**Feasibility Study
for the Groundwater Operable Unit
at Paducah Gaseous Diffusion Plant
Paducah, Kentucky**

Volume 1. Main Text

Subject: 1) Transmittal of the *Feasibility Study (FS) for the Groundwater Operable Unit at the Paducah Gaseous Diffusion Plant, Paducah, Kentucky* (DOE/OR/07-1857&D2) Primary Document

Subject: 2) Comments on the Internal Draft Revised Feasibility Study for the Groundwater Operable Unit at the Paducah Gaseous Diffusion Plant, Paducah, Kentucky (DOE/OR/07-1857&D-Internal Draft)

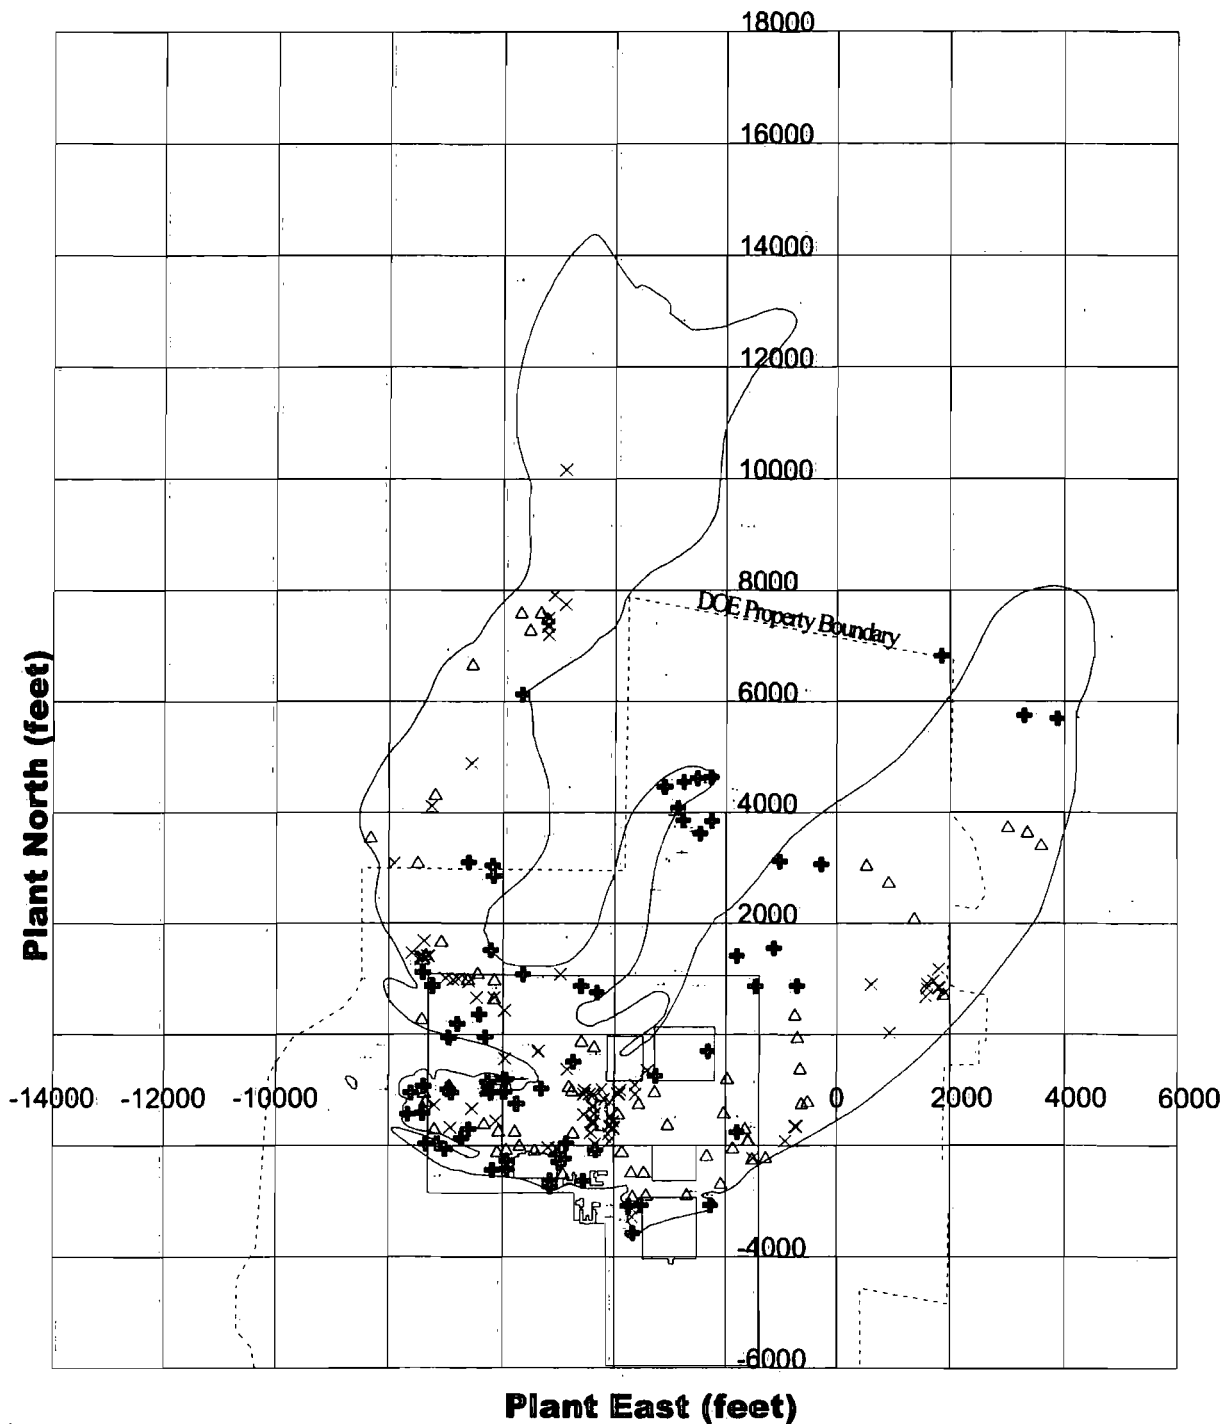
Comment Number	Sect. Page/Para.	Reviewer and Comment	Response
147.	Volume 1; Sect. 1.1.1; Page 1-6; Fig. 1.2	<p>KDEP:</p> <p>"This figure in part illustrates DOE's newest interpretation of offsite TCE contamination. One of the most striking elements of this interpretation is the existence of a 'finger' of dissolved phase TCE located between the site's two primary contaminant plumes. It appears that the only well control available in this area is located to the north of the C-746-U Landfill. By themselves, these wells do not provide sufficient control to justify the 'finger' interpretation. How was this interpretation developed? Was data from the data gaps project used to arrive at this interpretation? Provide answers to these questions in the D2 document."</p>	<p>Agree. Text has been added identifying the plume maps as the calendar year 2000 interpretation and referencing the source of documentation for the plume maps.</p>

Fig. 1.8. Hydrogeologic units.

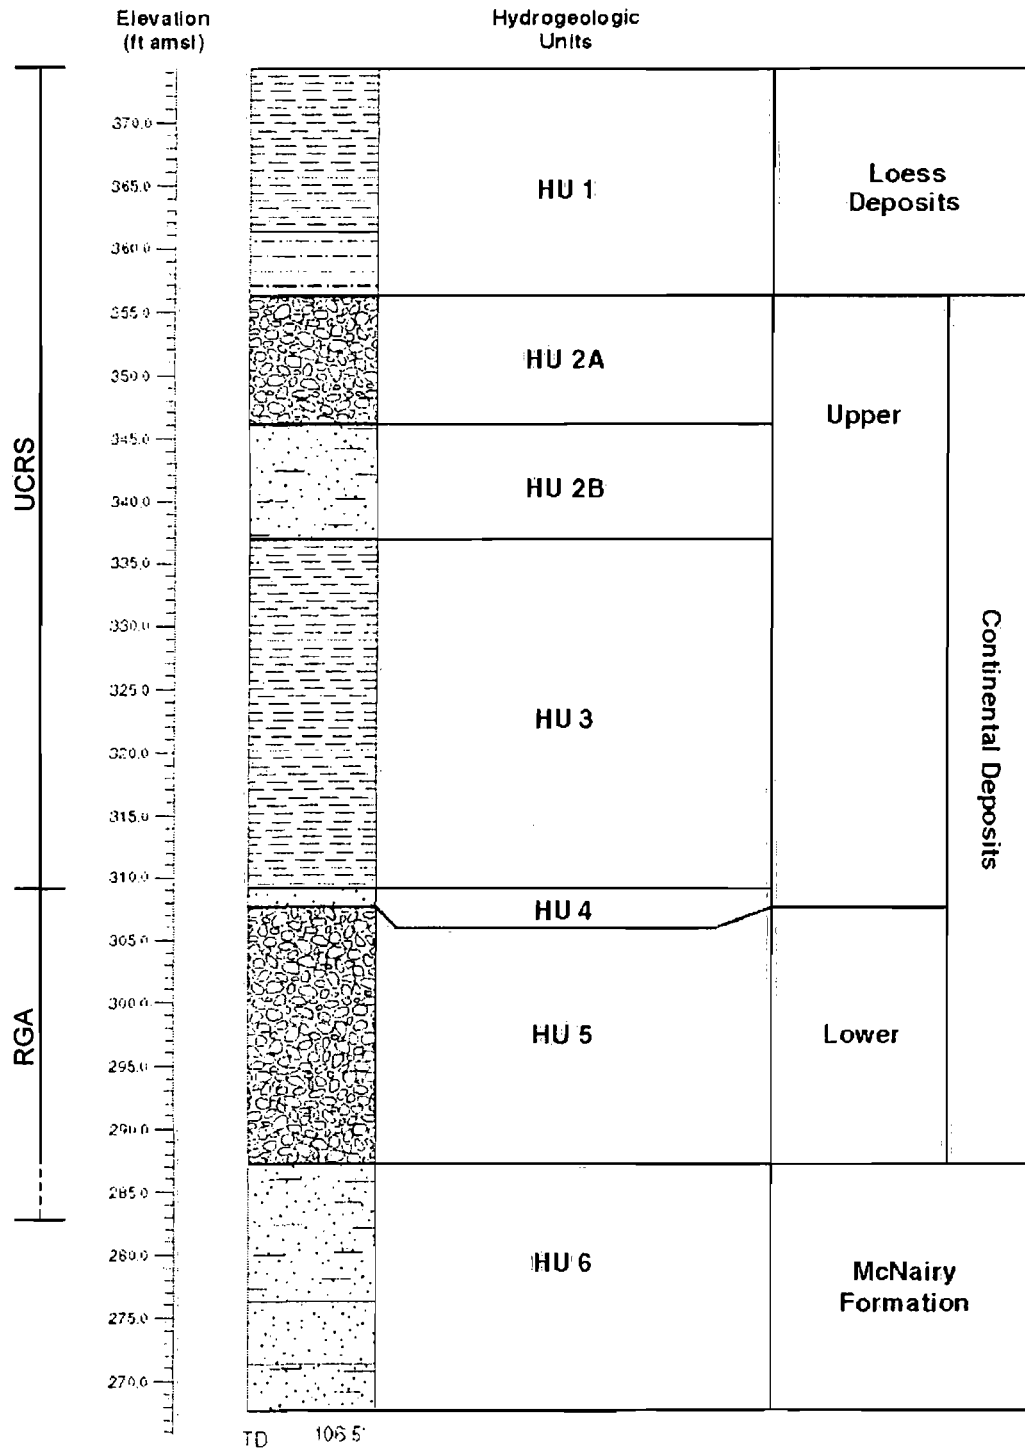
16.	Figure 1.8	NRE/B. Robinson: "The HU terminology serves no purpose. Suggest dropping all reference to HUs. If you want to continue to use this terminology, then correct Figure 1.8. The RGA includes HU 4 and HU 5. The Upper Continental deposits include HU 2 and HU 3 (and maybe HU 1 according to the bullets on Page 1-28). Part of the McNairy is HU 5 also. Why bother introducing this HU terminology when it is not used for anything useful once it is described? Apparently HUs do not play any part in RA selection because the information is never mentioned outside introductory section. No value added."	Disagree. The hydrogeologic units (HUs) are an important aspect of the conceptual model, forming the basis for aggregating data for risk assessment, fate and transport modeling, and evaluation of nature and extent. Figure 1.8 has been revised to clarify the relationship of the HUs to the UCRS and RGA. Hydrogeologic units are anticipated to be an important basis for the description of remedial actions in the upcoming PRAPs and RODs.

Fig. 1.10. Conceptual site model for the PGDP.

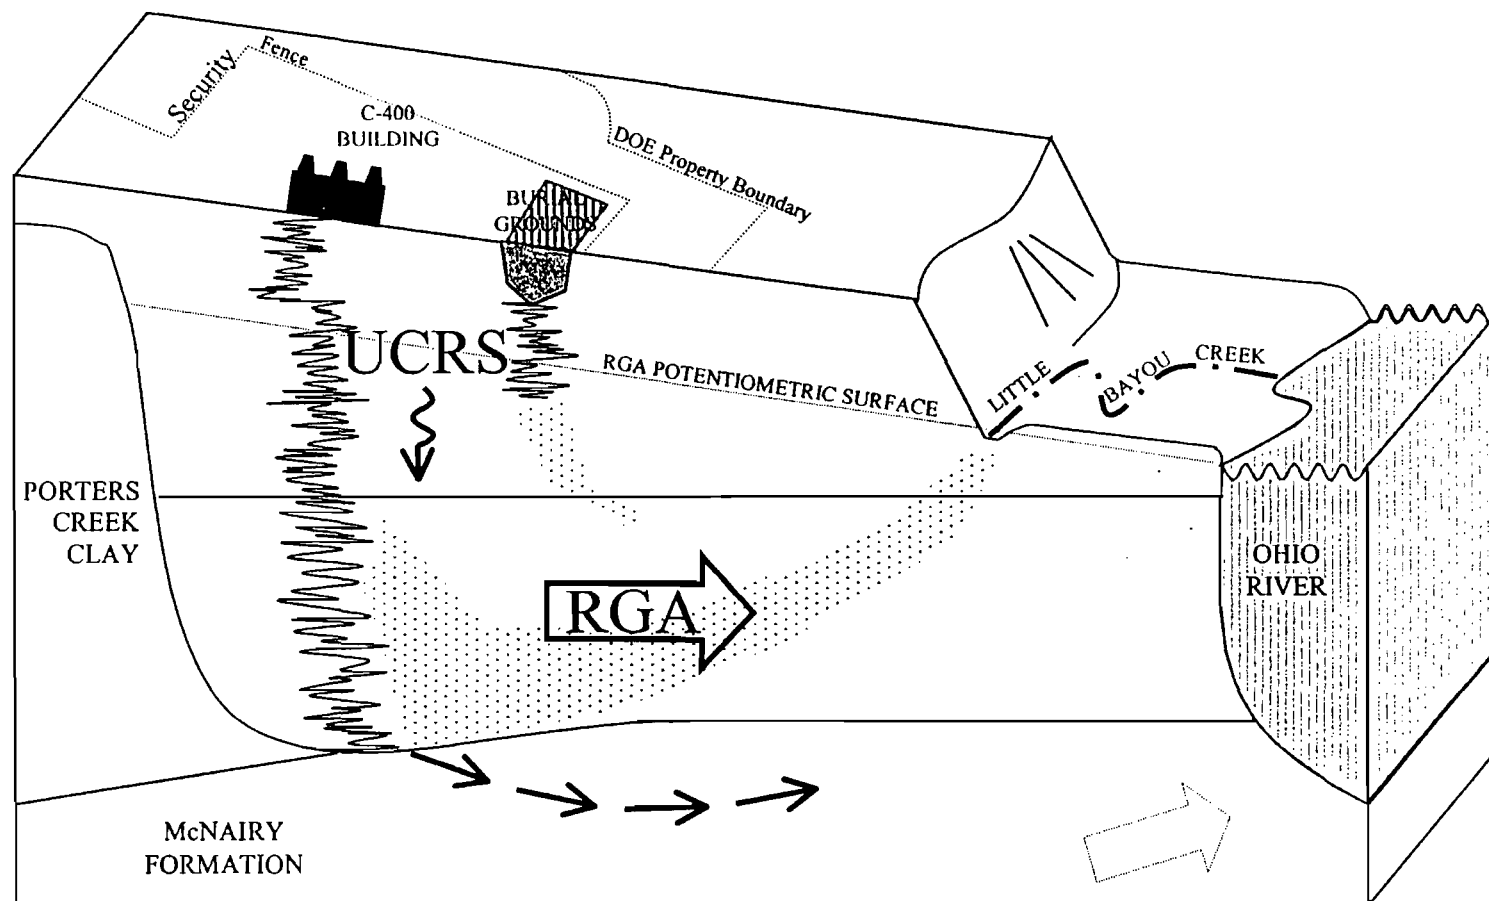
19.	Fig. 1.10	<p>NRE/B. Robinson:</p> <p>"This is a poor drawing. The perspective/orientation are terrible. It gives the impression that water flows uphill."</p>	<p>Agree. The drawing has been revised. Note: groundwater does flow "uphill" - from higher to lower hydrostatic pressure - in western Kentucky.</p>

20.	Page 1-26; Bullet 4	<p>NRE/B. Robinson:</p> <p>"This statement on discharge is too strong considering the discharge pathway to the surface shown in Figure 1.10."</p>	<p>Agree. Text has been reworded to read, "...nearly all of the regional groundwater flow...."</p>

Fig. 1.13. Predicted Tc-99 activity concentrations at the PGDP receptor locations due to loading from WAG 6.

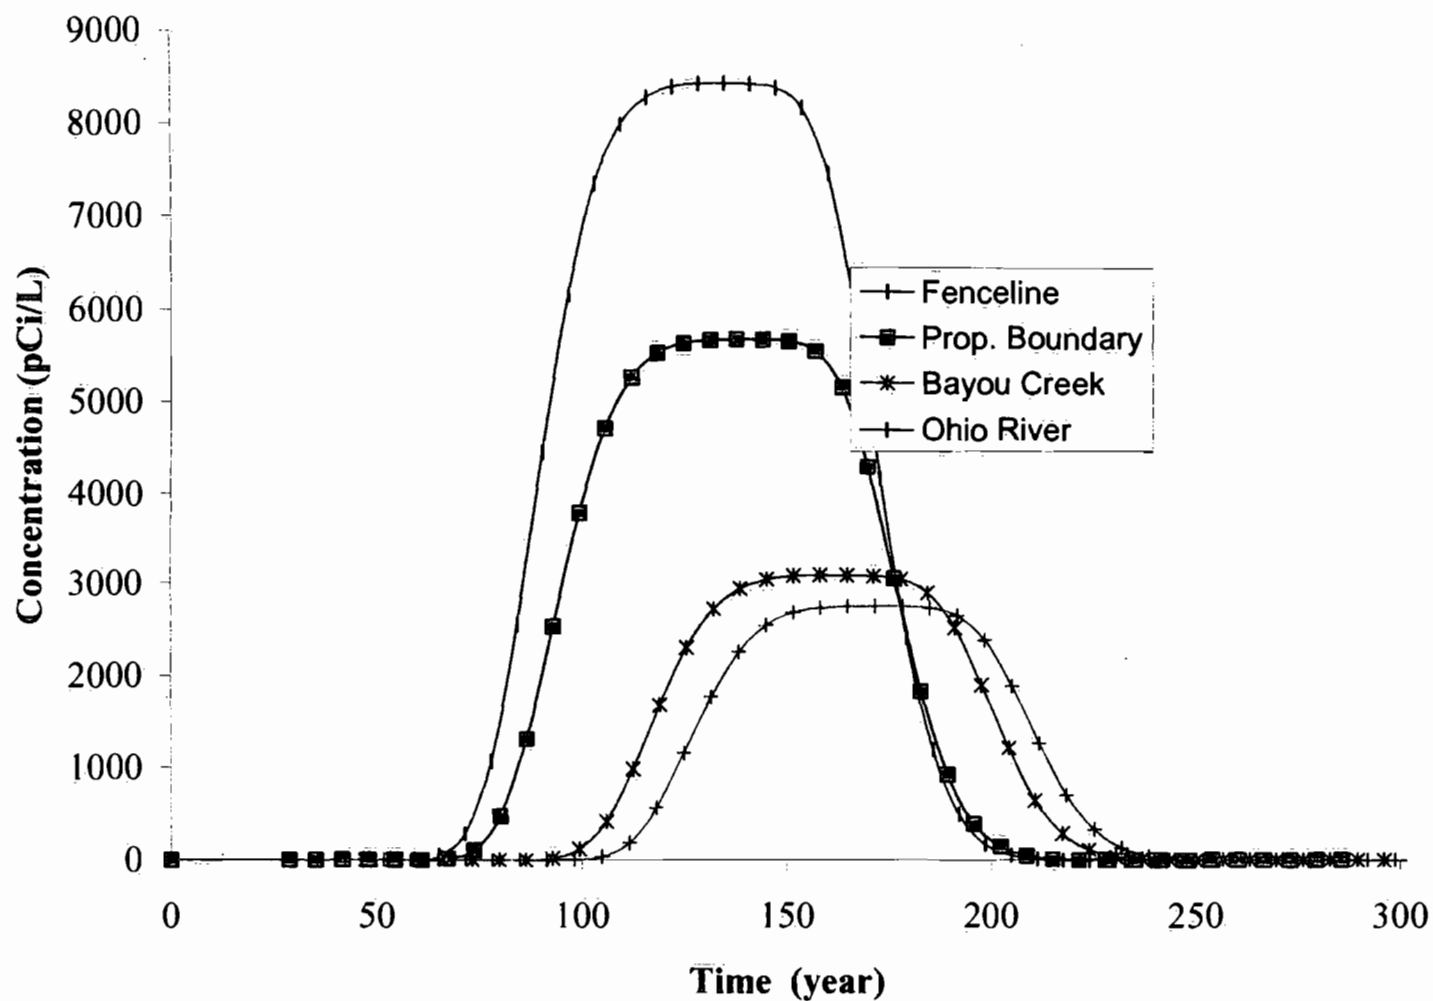
Comment Number	Sect. Page/Para.	Reviewer and Comment	Response
108.	Sect. 1.2.5.2; WAG 6.	<p>EPA:</p> <p>"In the last paragraph of this subsection, Figure 1.13 is used to present the plots of MEPAS predicted groundwater concentrations for Tc-99 versus time. It is also noted that figures for the remaining CM COCs (i.e., TCE, vinyl chloride, antimony, U-234, U-235, and U-238) are presented in Appendix C3. Based on the fact that seven CM COCs are identified for WAG 6, figures for each CM COC, not just ⁹⁹Tc, should be presented in this volume of the FS rather than just one in section 1.2.5.2 and the others in an appendix. If all seven figures are not presented, then justification as to why only ⁹⁹Tc is presented must be included in the text."</p>	<p>It should be noted that there are multiple WAGs and for each WAG there are multiple CM COCs that are modeled to four receptor locations. Figures were generated to present the predicted groundwater concentration for each of these CM COCs at the four receptor locations based on contributions from each WAG separately and also based on combined contributions from these WAGs. In total, more than 60 figures were generated. If all these figures were included in the main body of the text, then the discussion would become clumsy. Therefore, only ⁹⁹Tc, an indicator CM COC, is selected for presenting a representative figure.</p>

Fig. 1.17. Predicted vinyl chloride concentrations in the atmosphere due to contaminated soil in the WAG 6 (Sector 4).

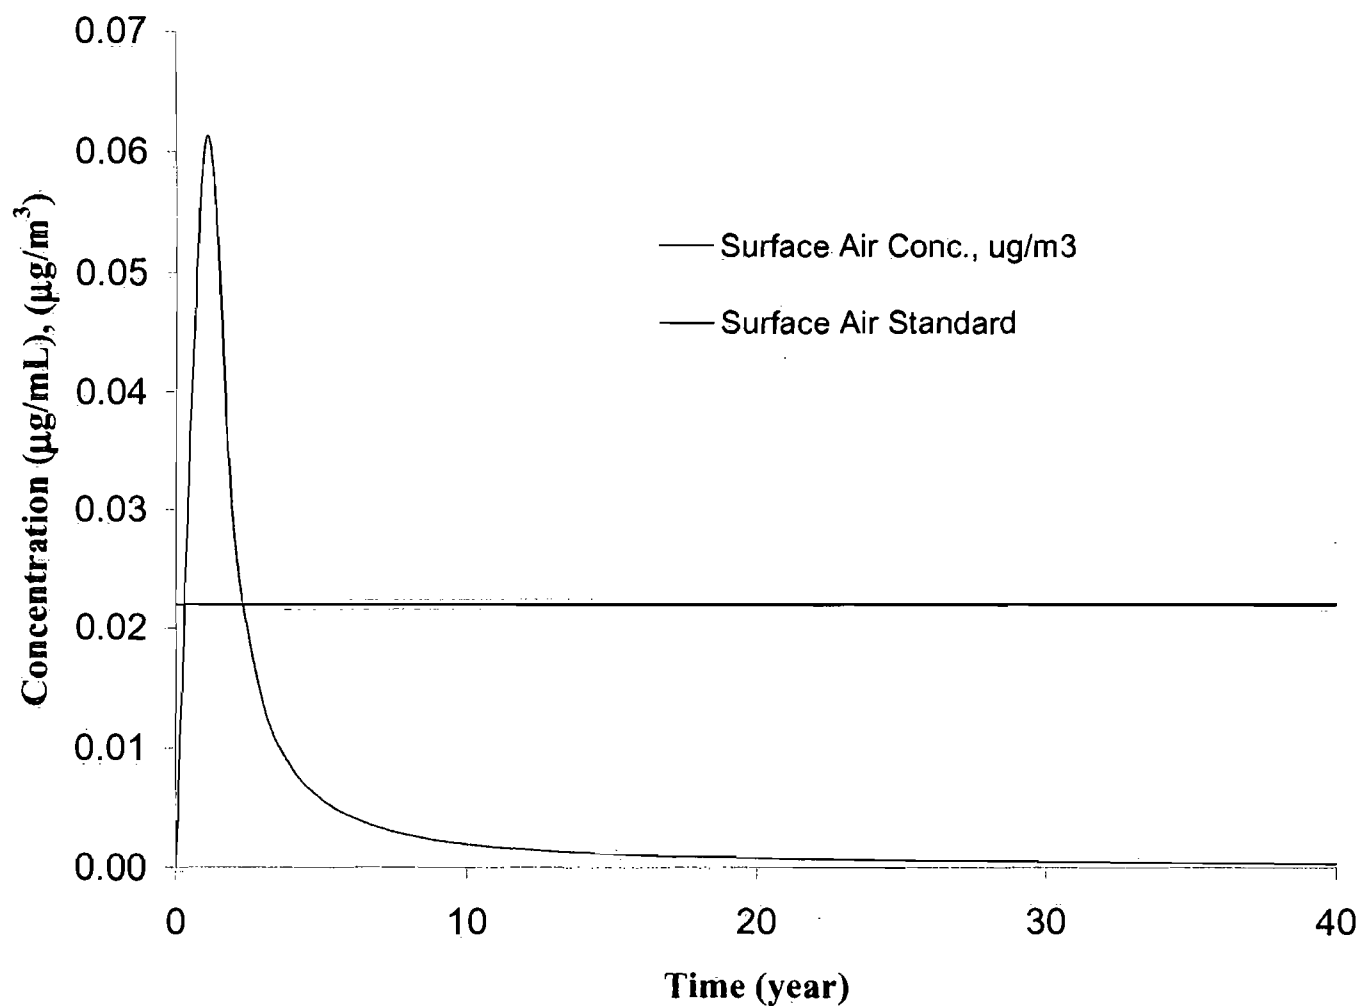
Comment Number	Sect. Page/Para.	Reviewer and Comment	Response
31.	Figure 1-17	NRE/B. Robinson: "Should the plot indicate something about the exposure distance to the source (100 meters)?"	See response to Comment #27.

Fig. I.18. Areas used in BHHRA.

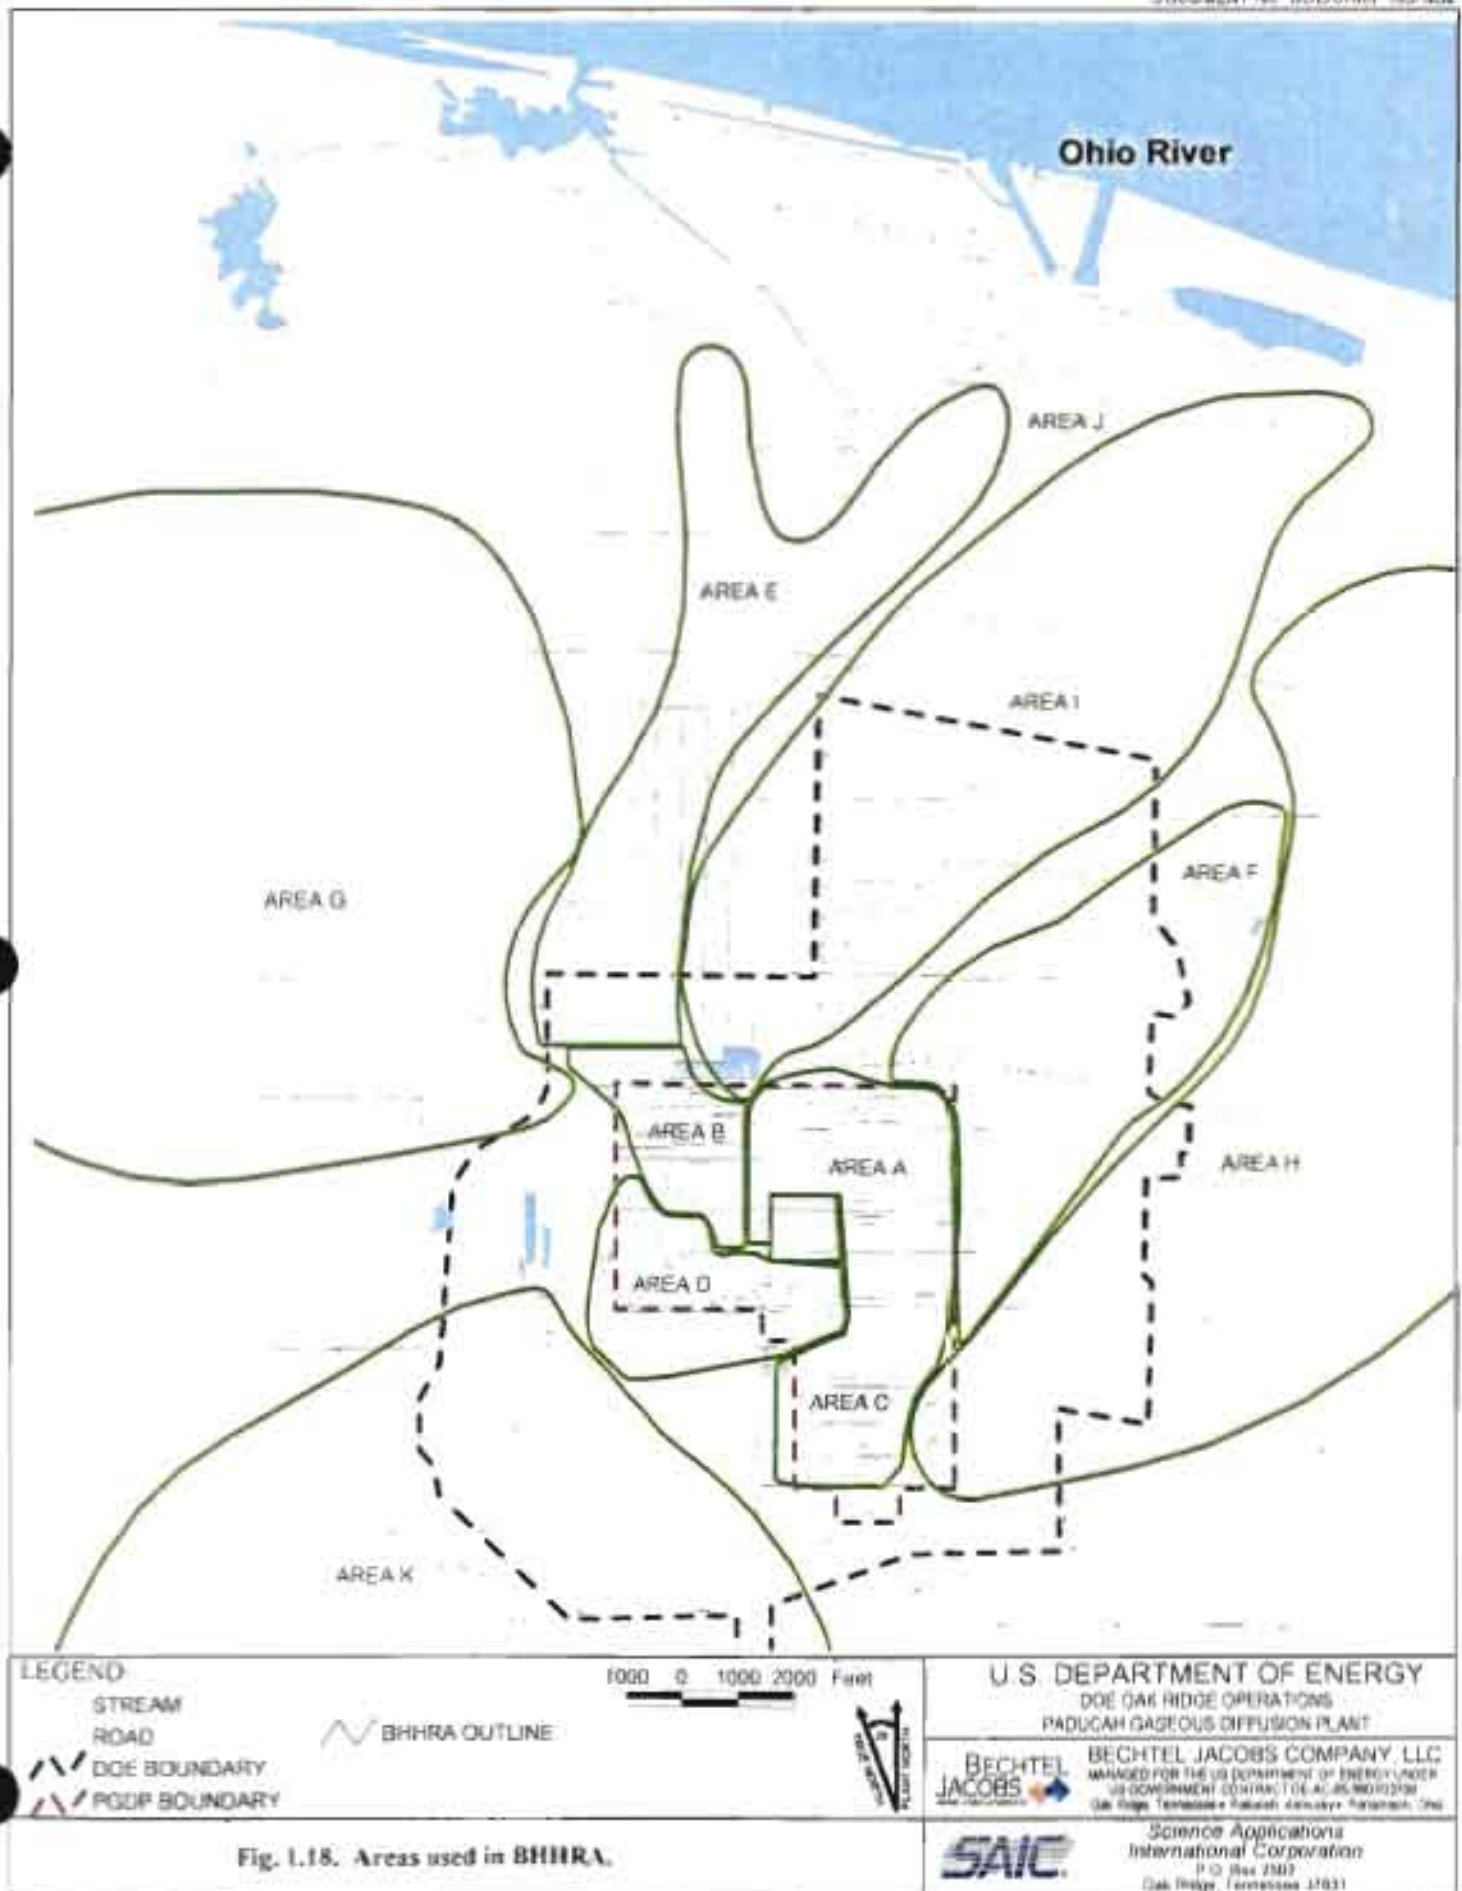
Comment Number	Sect. Page/Para.	Reviewer and Comment	Response
36.	Figure 1.18	NRE/B. Robinson: "Inadequate caption."	Disagree. The caption adequately notes that the areas used in the BHHRA are depicted. No change was made to the document in response to this comment.
